<p>TO:</p> <p>George W. McAlpin Chief Engineer Bldg. 5 Room 401</p> <p>SUPERSEDED BY EI 77-031 EFFECTIVE 5/1/1977</p>	<p align="center">ENGINEERING INSTRUCTION</p> <p align="center">NEW YORK STATE DEPARTMENT OF TRANSPORTATION</p> <p>SUBJECT: STANDARD DETAILS FOR HIGHWAY BRIDGES, REVISION TO</p> <p>Subject Code: 7.35-11</p>
<p>Distribution:</p> <p><input type="checkbox"/> Main Office <input type="checkbox"/> Regions <input checked="" type="checkbox"/> Special</p>	<p align="right"><i>Sup 77.50</i></p> <p>Code: <u>EI 74-36</u></p> <p>Date: <u>4/22/74</u></p> <p>Supersedes:</p>
<p>APPROVED:</p> <p align="center"><i>R. N. Kemp</i></p> <p align="center">Deputy Chief Engineer (Structures)</p>

The attached pages are revisions to Standard Details for Highway Bridges and should be inserted in your manual immediately:

Example of Tension Zones to be
Indicated on the Plans
(Refer to Section 27.6)

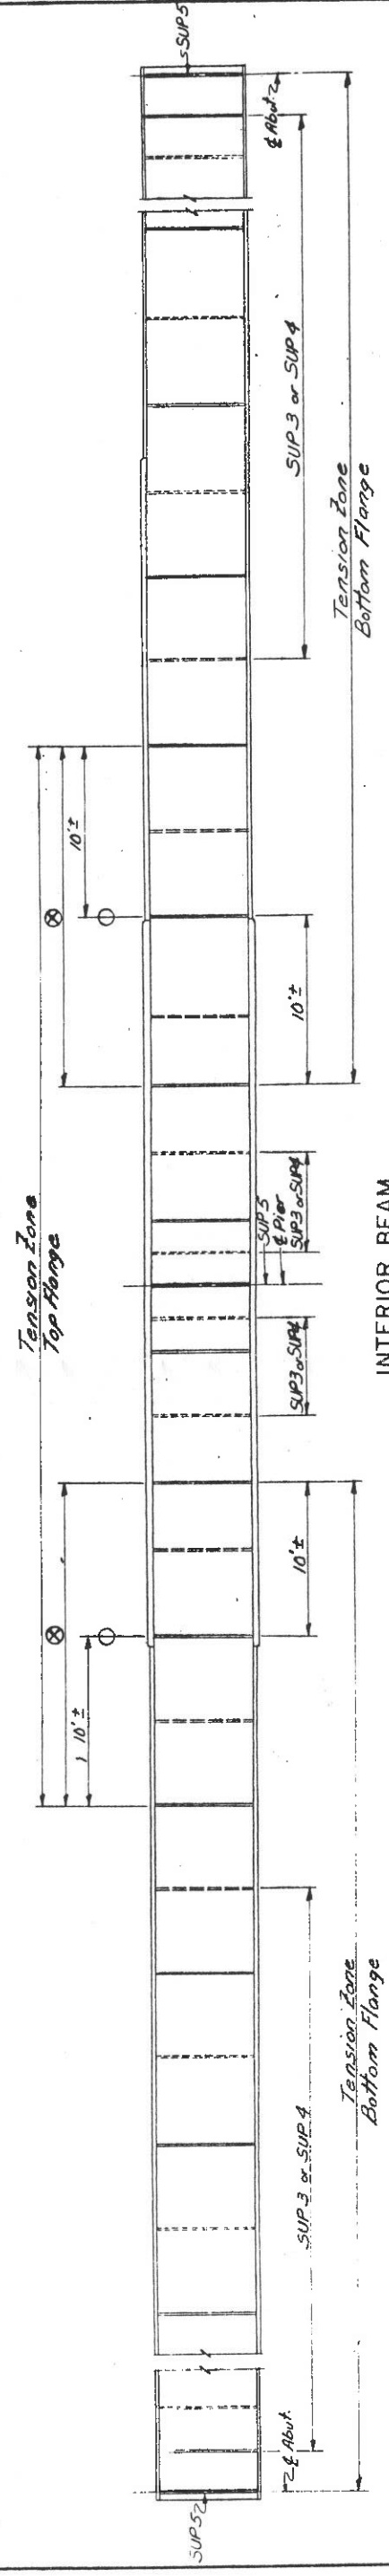
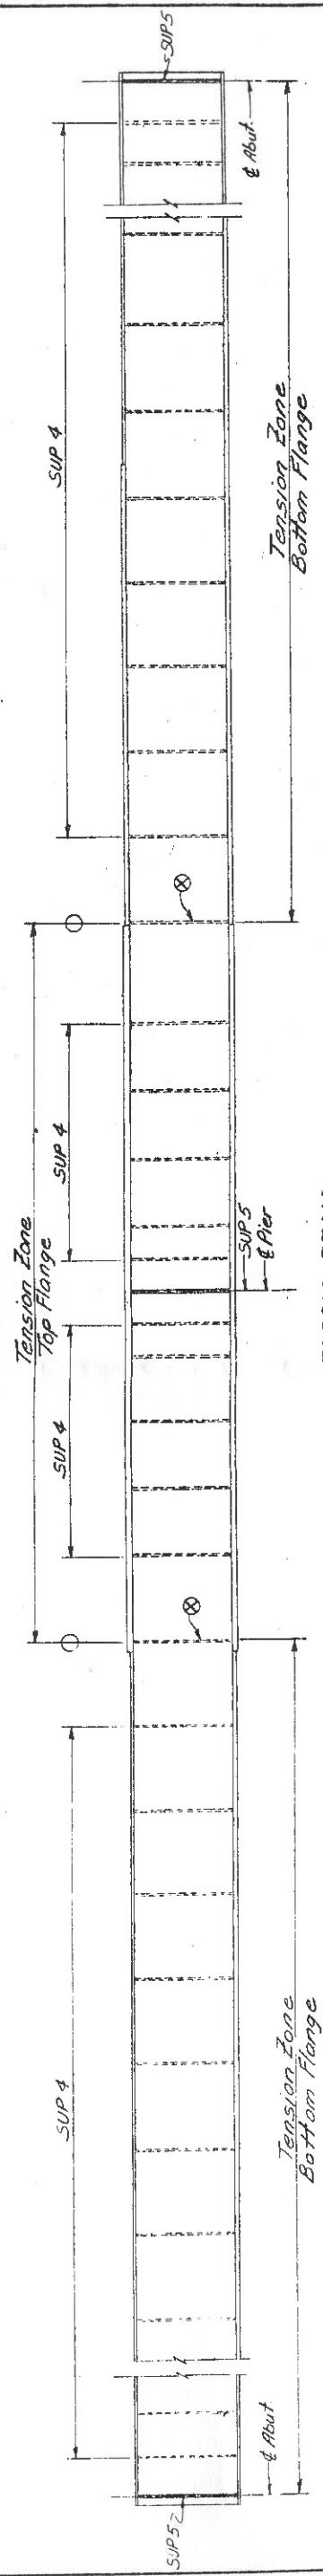
- P - Pedestals. Added "and Piles".
- S - Shaft. Deleted "Use also for Cast-in-Place Piles".
- T - Top of Slab (Highway Approach Slab Only) - Deleted.
- Page 99 - Last line on page - deleted.
- Page 100- Spacing of Diaphragms - Deleted and new paragraph added.
Section 26. 3. 2. - No change.
Section 26. 4 - Covers new section title and details.
- Page 101- Sections 26. 5, 26. 6 and 28. 7 - Renumbered.
Were formerly 26. 4, 26. 5 and 26. 6 respectively.
- Page 102- Added, due to revisions and rewriting pages 100 and 101.
- Page 105- Third line - Revised.
- Page 106- No change.
- Page 119- New page added. Back of page is blank.
- Page 119A - TENSION ZONES - Added.
- Page 120- New page added. Back of page is blank.
- Page 120A - BAR LIST WITH DIAGRAMS - Added.
- Page 120B- BARLIST - Added.

T Denotes Point of Dead Load Contraflexure.

⊗ Denotes Fitted stiffeners & fitted connection plates. Stiffeners and connection plates shall be cut to fit and shall not be driven in place with sufficient force to distort the flange, web, stiffener or connection plate. Stiffeners and connection plates shall be welded to the web and placed point tight against both flanges.

NOTE TO CONTRACTOR:
WITHIN THE TENSION ZONES DELINEATED THERE SHALL BE NO CUTTING, WELDING PERMITTED ON THE PLATES, NAILS DETAILLED ON THE ATTACHMENT OF FORMS, TIES, ETC. SHALL NOT BE PERMITTED.
